RIFT apartments

Design Recommendation Meeting | 2

10 28 2019

SDCI no. 3027511

West facade | EDG + DRB 1

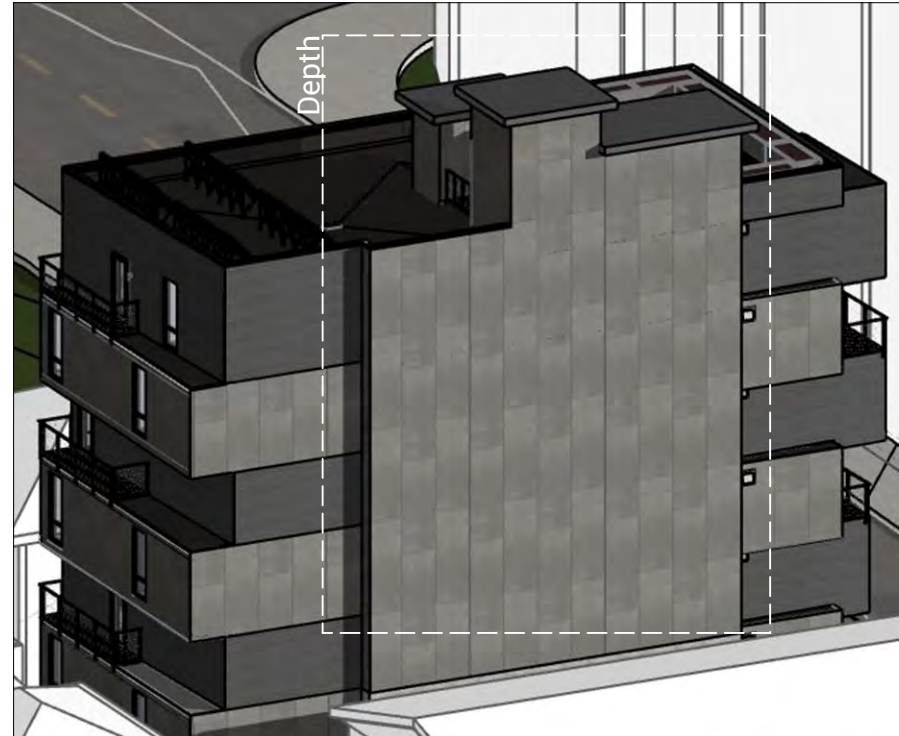
e | The Board noted the visibility of the west façade and was concerned about this large and highly visible blank wall. The Board recommended introducing glazing on this façade to help reduce the perceived mass and add visual interest. If privacy is a concern, use window geometry and/or glazing opacity to reduce impacts. (DC2-B-2, DC2-5)

c | The Board was concerned about how the various materials meet on the west façade, which does not feature the same

found on the other facades. Simplifying the material palette, as described in item "a", will assist with this, but concerns remain related to how material transitions, which are tied to dramatic moves on other facades, will come together when coplanar. (DC2-B-1, DC2-2)

e | Introduction of glazing along the west facade, specifically where the board encouraged, is not feasible due to the egress nature of the interior spaces at that location. As the cladding wraps around the building, the design has been simplified in relation to the west facade. Per the board recommendation, the vertical circulation core has moved west and created modulation so that the west facade is no longer coplanar. Metal mesh for vine growth has been added to the lower levels over the board formed concrete to add interest at the ground level.

c | The west facade has been modulated per the board recommendation and is no longer coplanar. See response to Massing & Architectural concept item "e".

DRB 1 | Sunken plaza

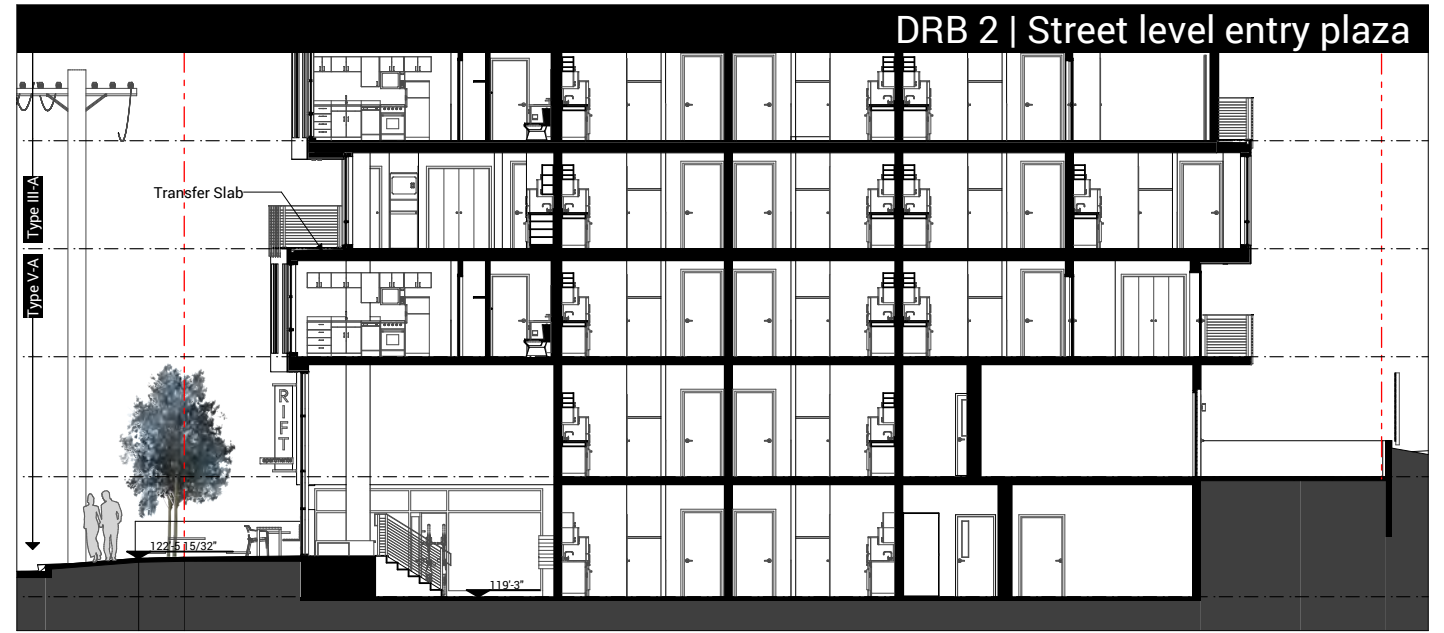
a | The Board did not support the sunken entry and directed the applicant to raise the building as needed to provide an at-grade entry on NE 42nd Street. (PL3-A, PL3-1)

a | The entry plaza has been raised to provide a strong at grade entry to the building from 42nd st.

Eighth floor balcony

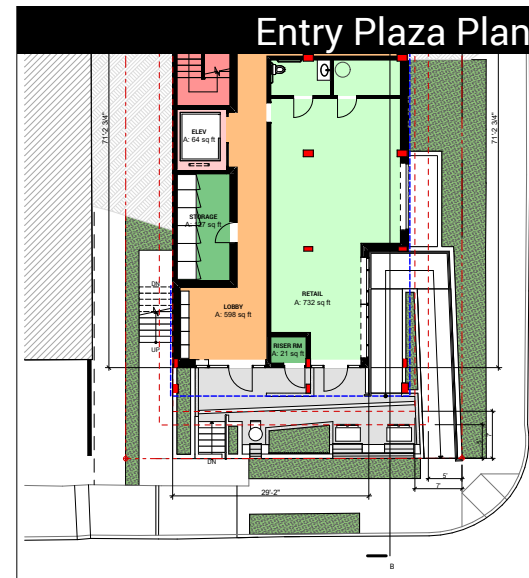
b | The Board observed that the majority of balconies are tucked into the building form, with the exception of the top floor where the balcony projects forward and appears to be “applied” to the façade. The Board found this inconsistency to be disruptive and directed the applicant to remove or redesign the top floor balcony to be more consistent with the balconies on lower floors. (DC2-B-1)

b | The top floor balcony has been revised to sink back into the building and not stick out.

1. Side Setback from Interior Lot Lines (SMC 23.45.518.B)

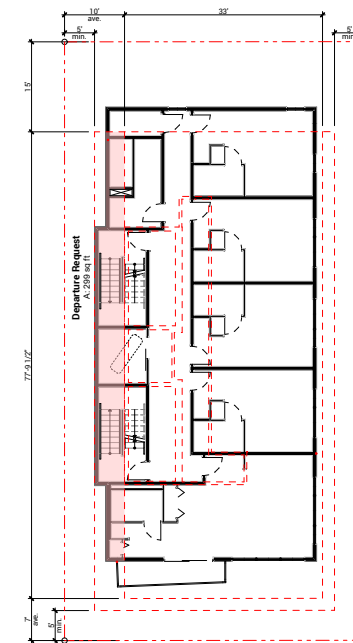
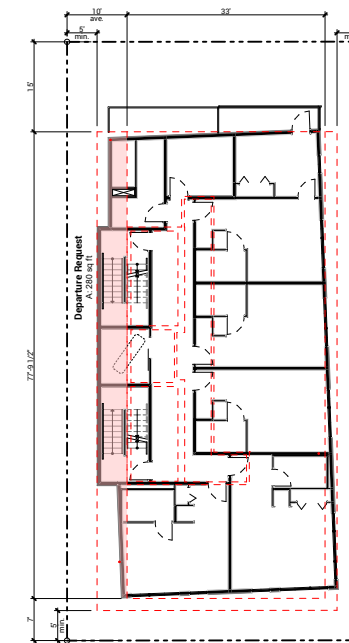
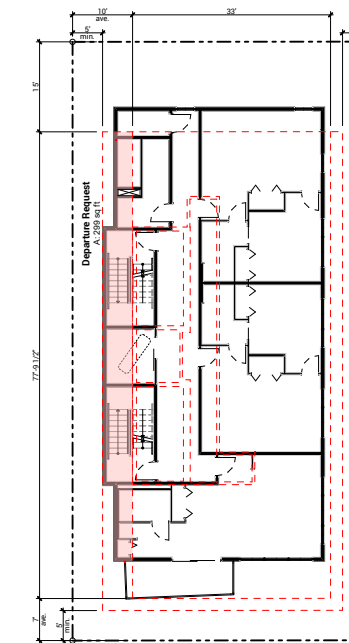
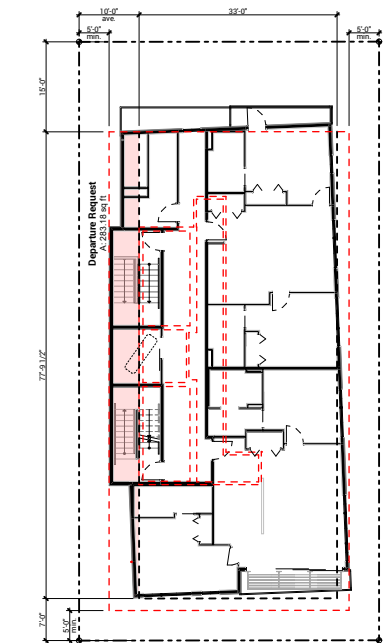
The Board indicated initial support of the departure request, provided the preferred massing option is well executed in response to the guidance, as the proposed design results in an interesting massing form with modulated facades. The resulting design better meets DC2-B-1 Façade Composition.

During the first DRB meeting the board encouraged modulation of the circulation core to provide a more dramatic facade along the west. This departure request has been amended to include that modulated area.

Rationale: Due to the narrowness of the site, providing an elevator core that meets the required setback at +42ft would make it impossible to modulate the building as proposed. The diagrams demonstrate that complying with this setback would disrupt the facade composition and visual impact of the design.
